FOUR RIDGE DAM  
JEFFERSON COUNTY, MISSOURI  
MISSOURI INVENTORY NO. 30446

PHASE I INSPECTION REPORT  
NATIONAL DAM SAFETY PROGRAM

PREPARED BY: ST. LOUIS DISTRICT CORPS OF ENGINEERS  
FOR: GOVERNOR OF MISSOURI

SEPTEMBER 1978

PHOTO 1: Upstream Slope Erosion

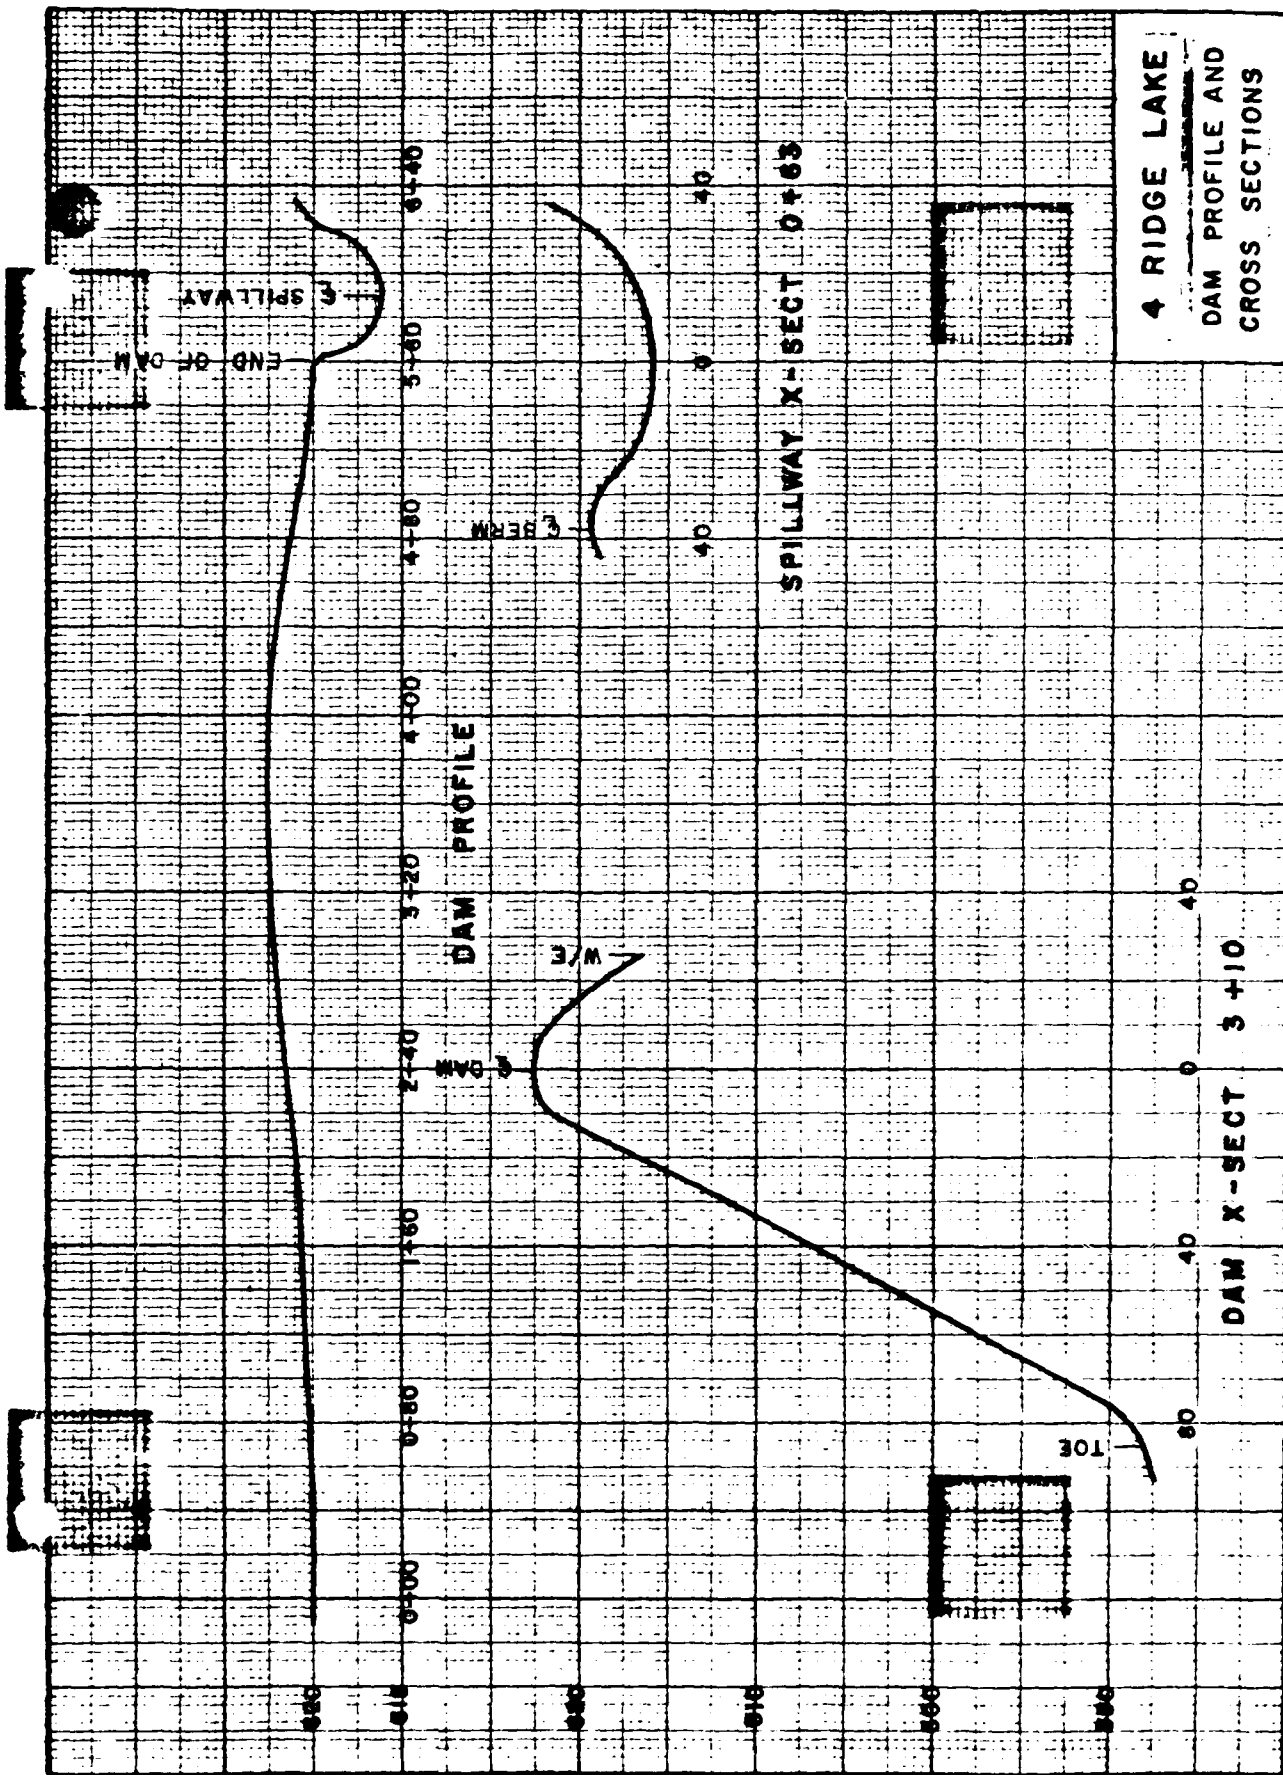
c. Dam. No detrimental settlement, cracking or seepage was noted on or near the dam. Severe upstream erosion was observed above the waterline. This erosion has caused a 2-foot to 3-foot vertical scarp to develop across the entire upstream slope (see photograph 1). The upstream slope showed no signs of riprap protection. On the downstream slope vegetation was 2 feet to 3 feet

high with several trees up to 1-1/2 inches in diameter (see photograph 2). Surface soils on the dam were silty and quite erodible as seen at localized areas of the upstream slope which were void of vegetation (see photograph 1).

The upstream face of the dam is subject to erosion and should be protected with riprap.

- (1) Remove trees and heavy vegetation from the downstream slope. Care should be taken during removal not to destroy the existing condition of the downstream slope.
- (2) Protect upstream slope with adequate riprap to prevent erosion.
- (3) Repair lower spillway erosion with riprap.
- (4) Remove the chain link fence constructed within the spillway.
- (5) At least every five years a detailed inspection of the dam should be made by an engineer experienced in design and construction of dams.
- (6) Seepage and stability analyses should be performed by a professional engineer experienced in the design and construction of dams.
